## ADDENDUM NUMBER ONE

May 22, 2025

**UI: Replace Chiller, CNR BLD. 055**

Engineer's Project Number: 231760

**M-601**

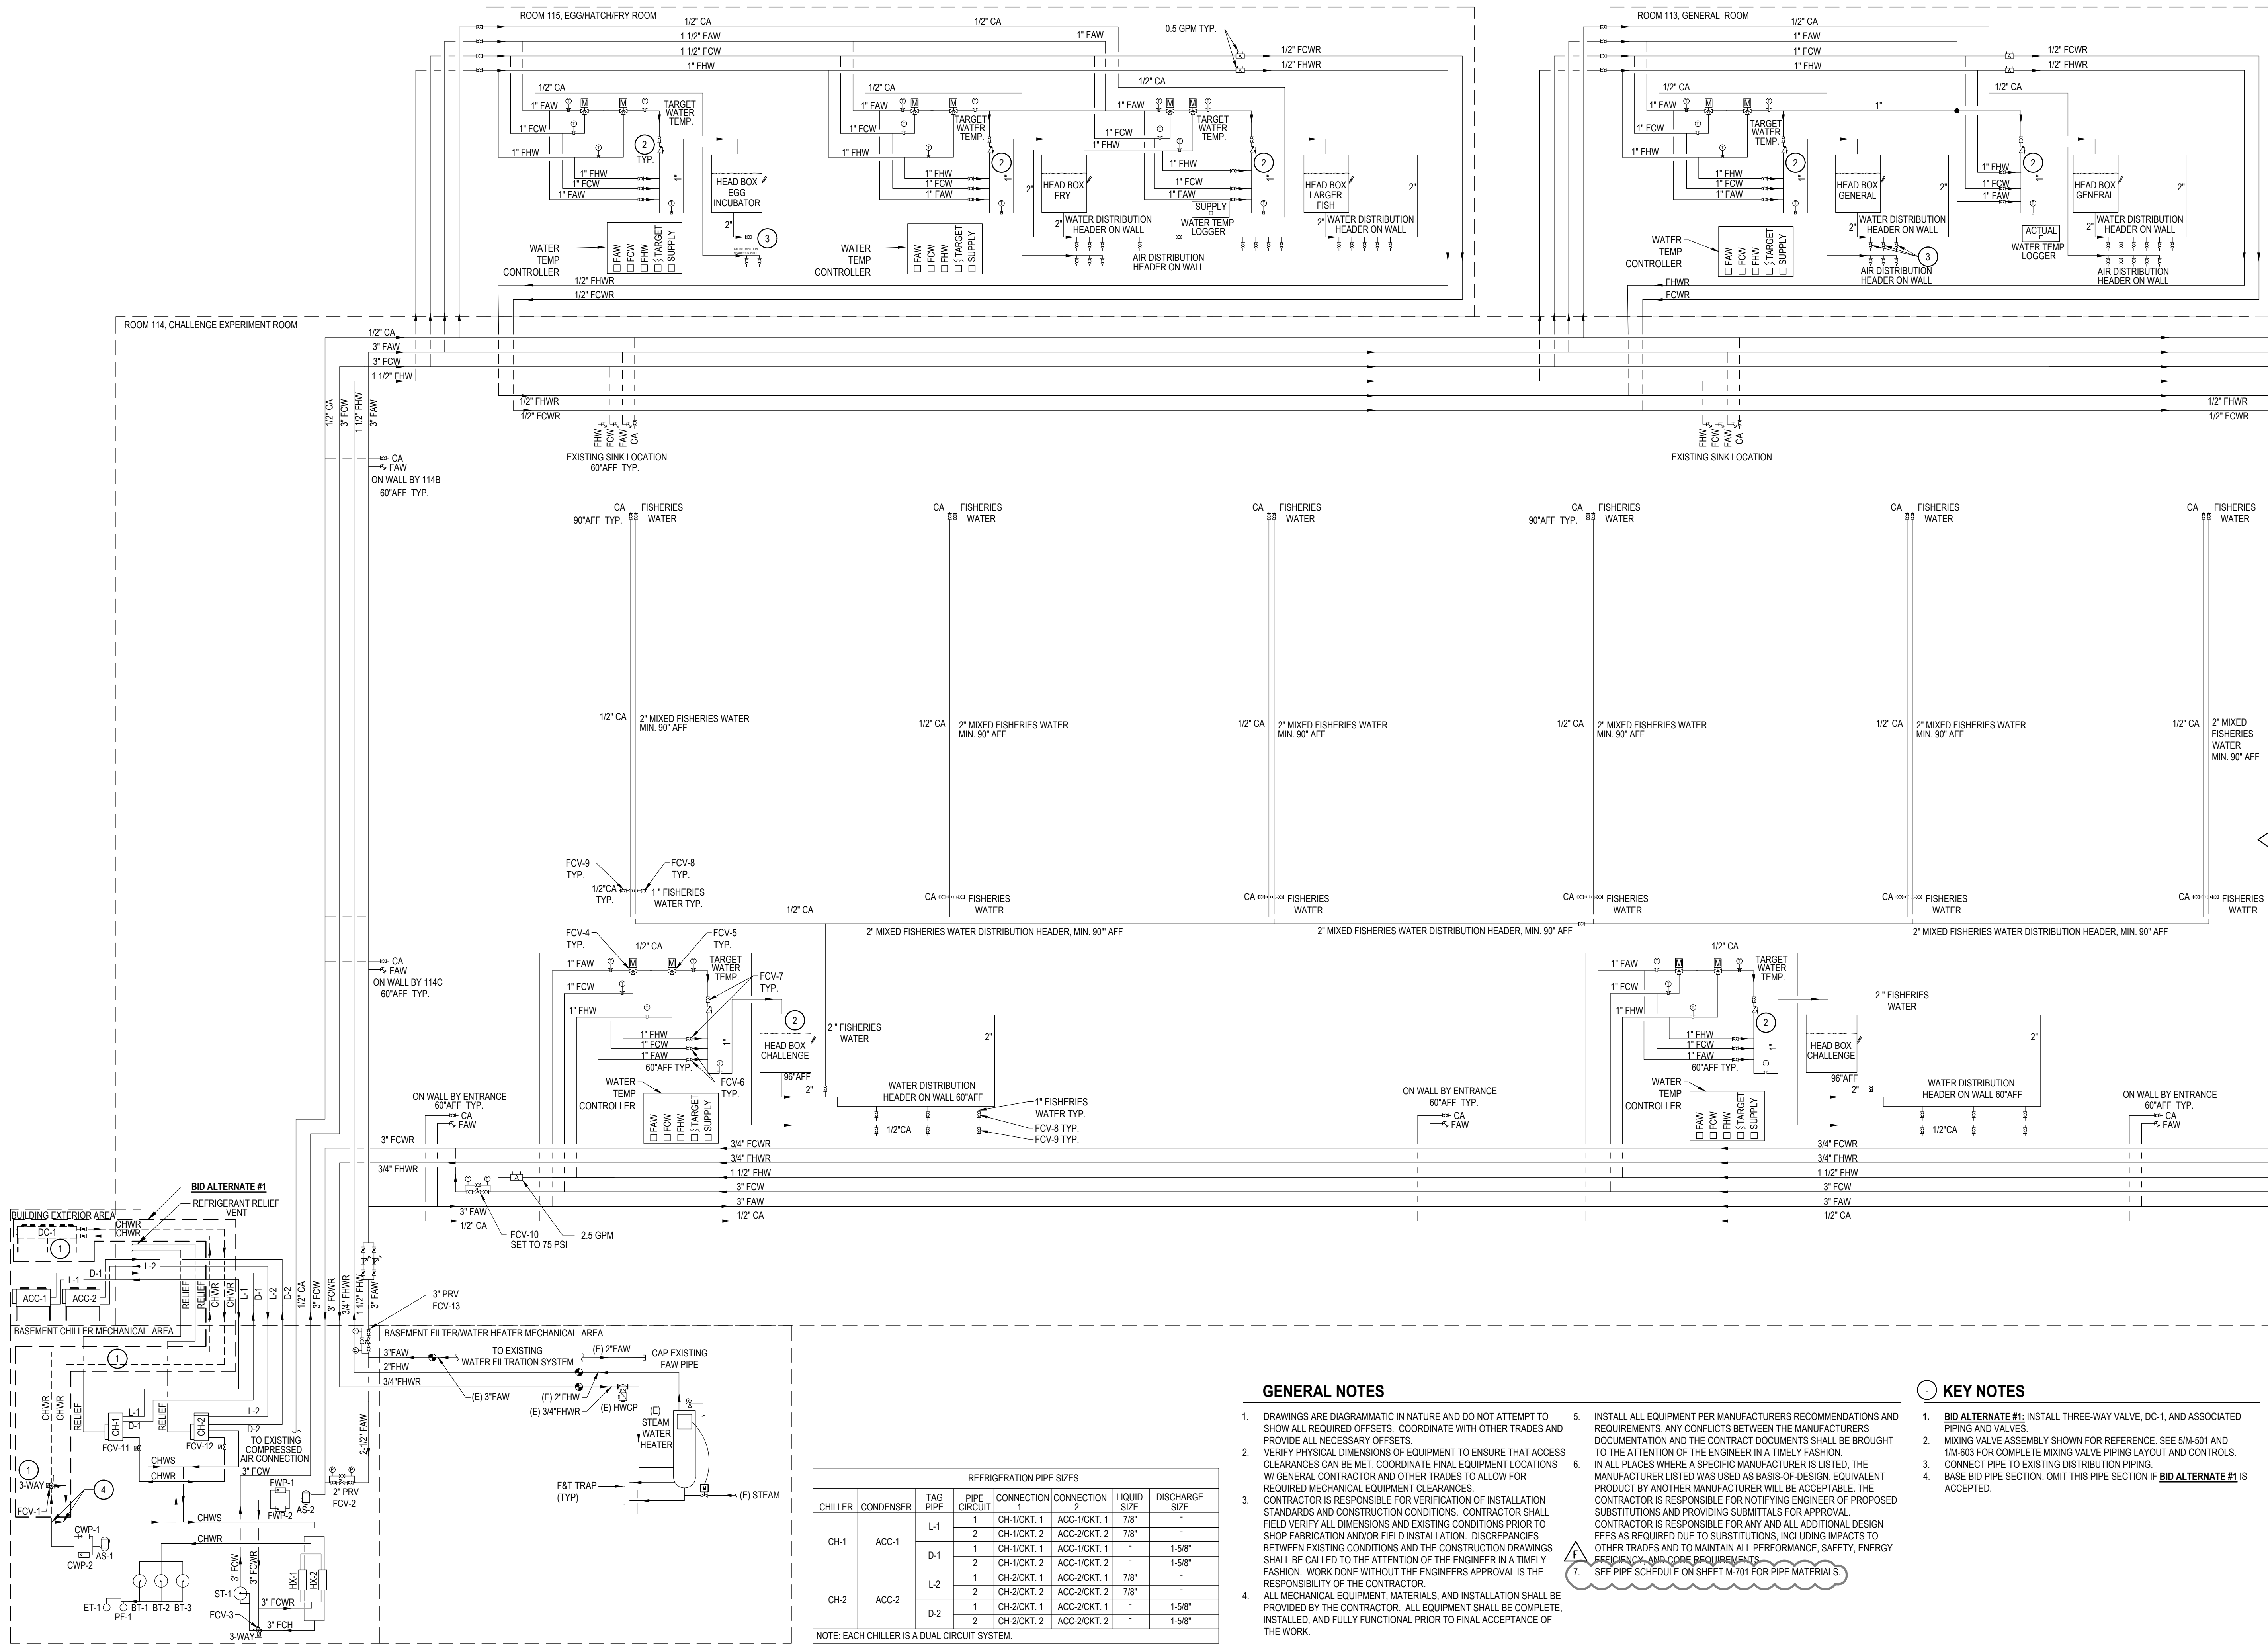
- II. Design sheet M-601 Mechanical Piping Diagram to have General note 7 added to specify fisheries water piping material.

- SEE PIPE SCHEDULE ON SHEET M-701 FOR PIPE MATERIALS.

**M-602**

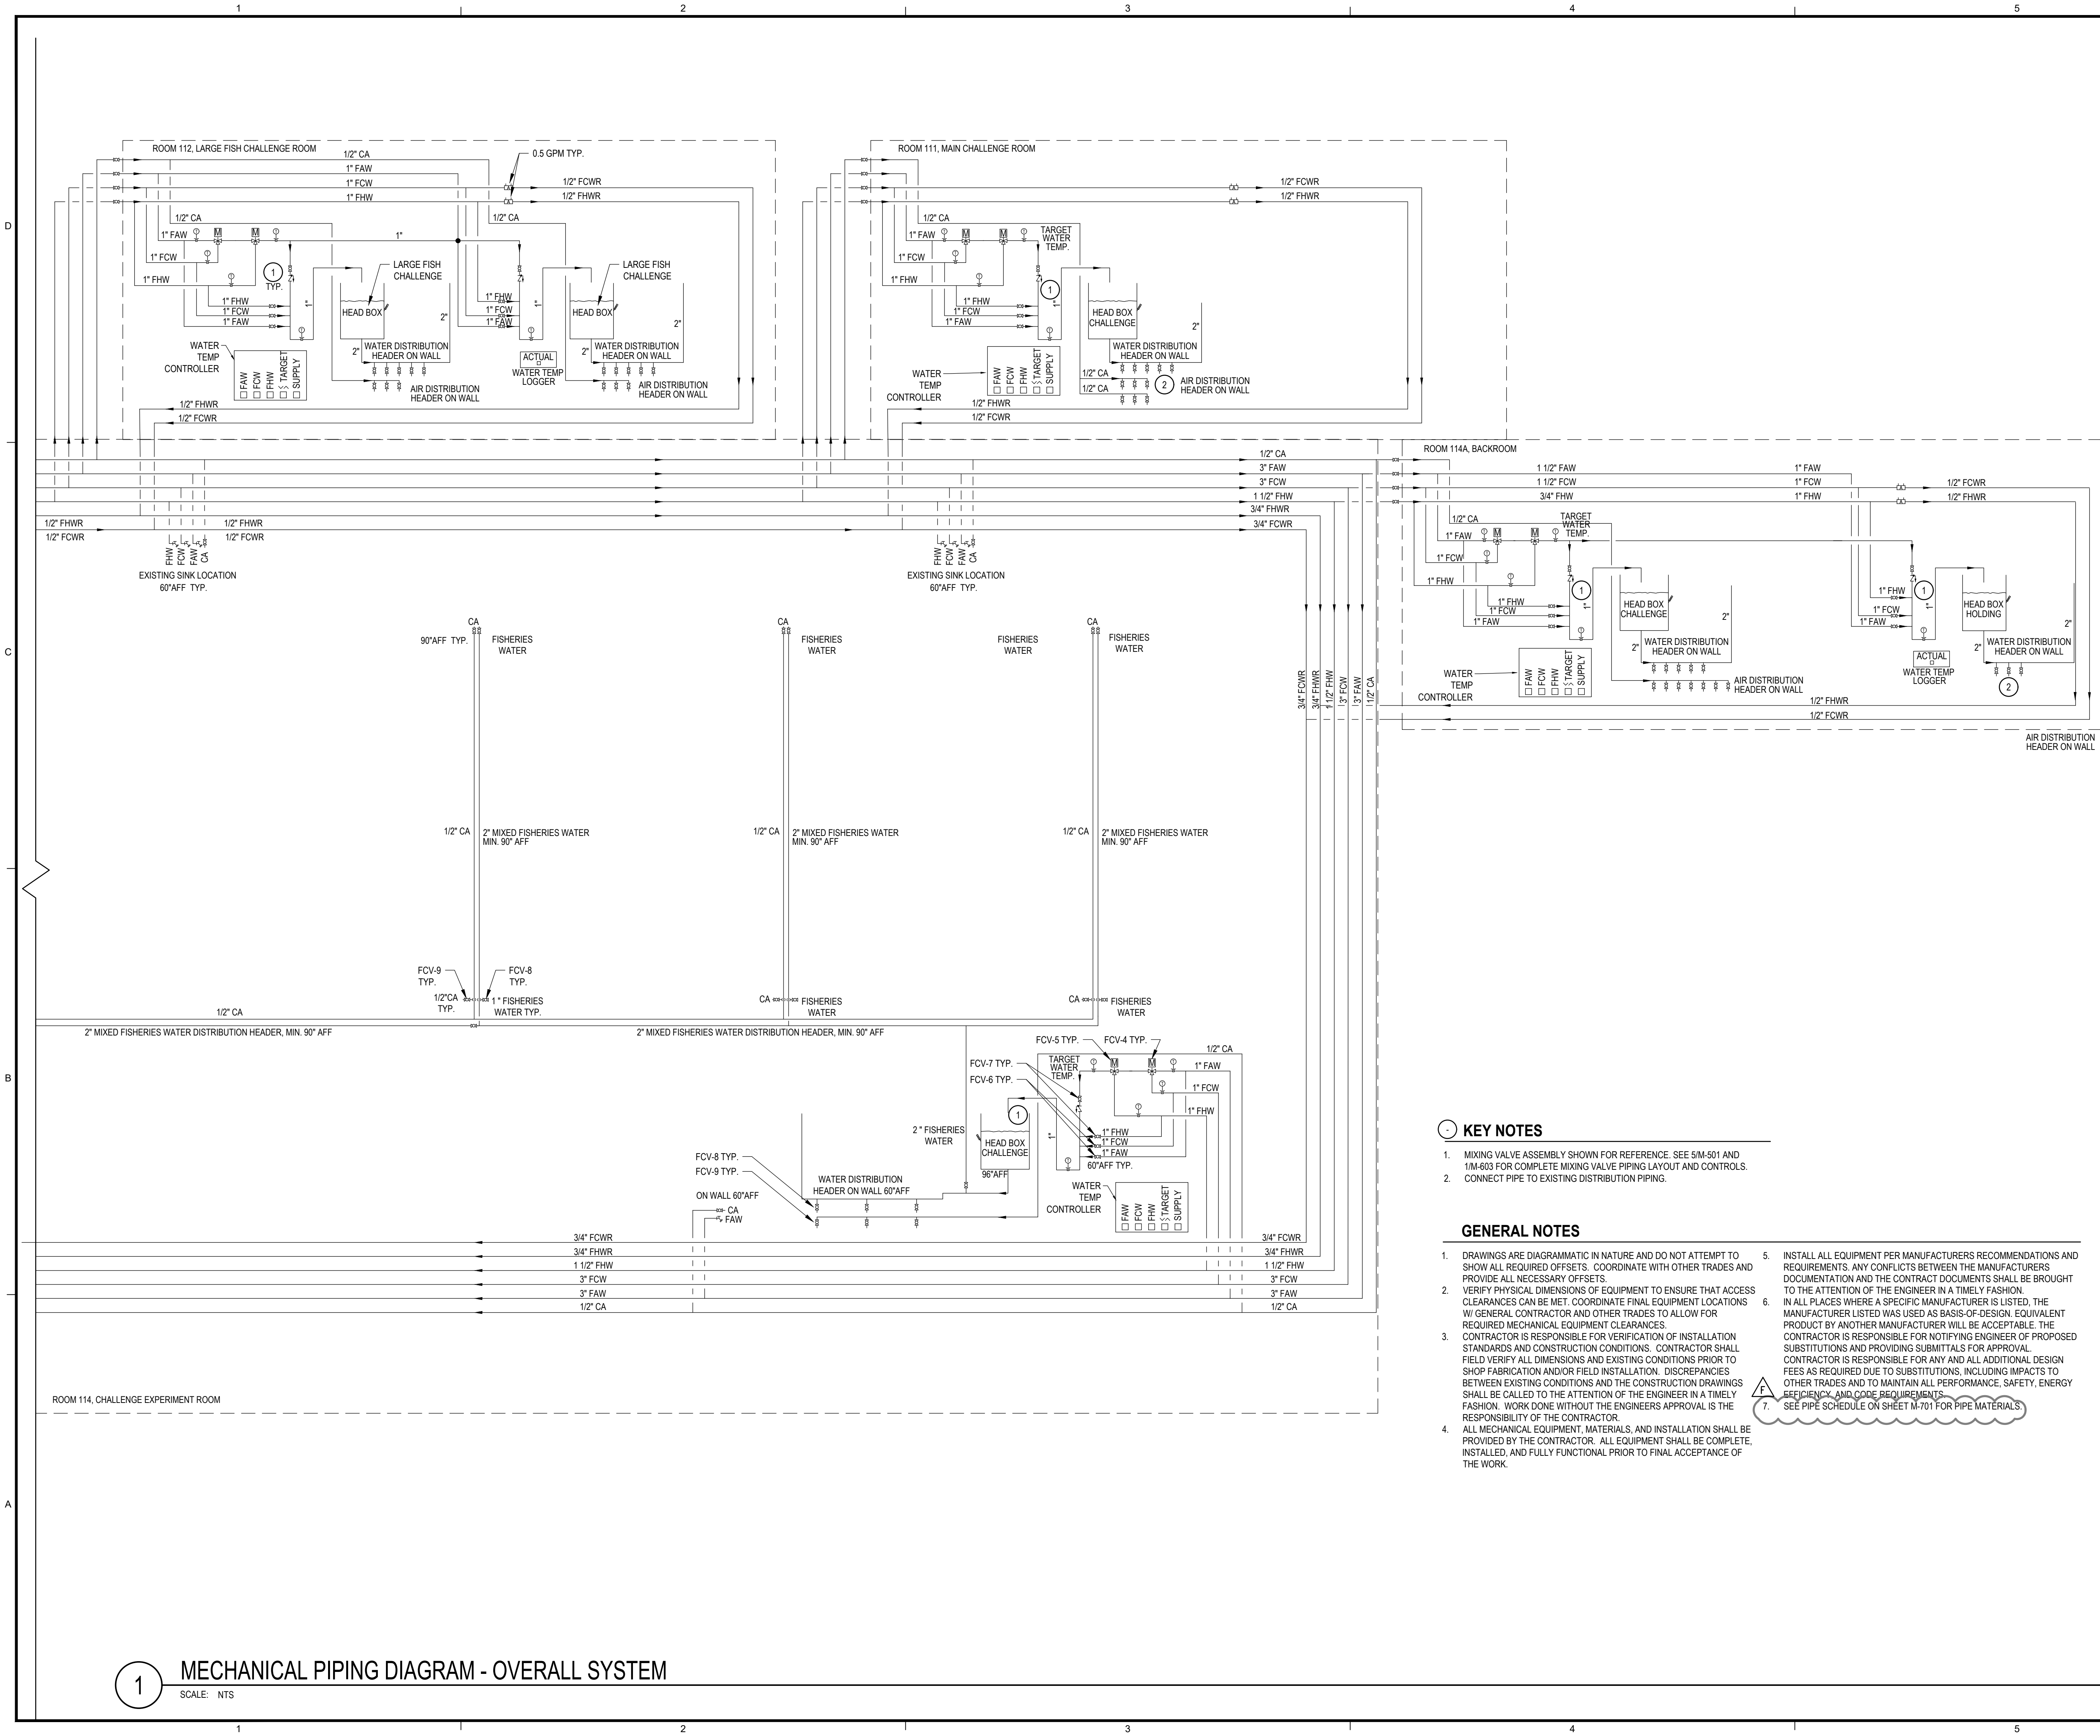
III. Design sheet M-602 Mechanical Piping Diagram to have General note 7 added to specify fisheries water piping material.

- SEE PIPE SCHEDULE ON SHEET M-701 FOR PIPE MATERIALS.
